## New switch for power windows

### Background

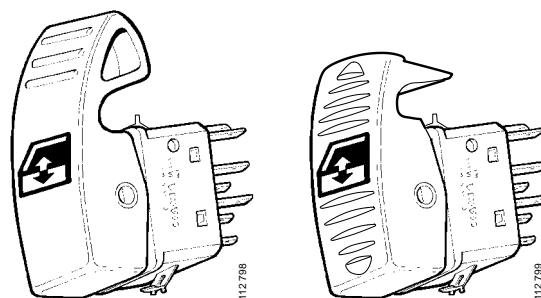
The power window switch has a return spring. This is located behind the black switch button.

When the driver climbs down from the cab he may catch on the power window switch and the black button may be forced loose. The spring behind the plastic switch also falls out and is lost.

In order to remedy this problem, a new shorter switch has been introduced into production from the following chassis numbers:

Designation	Outgoing part	New part
Switch	1 368 831	1 413 146

- Remove:
  - the switch panel in the door
  - the electrical connector.
- Carefully press in the metal plates which secure the switch to the panel and remove the switch.
- Install
  - the new switch.
  - the electrical connector.
  - the panel in the door.
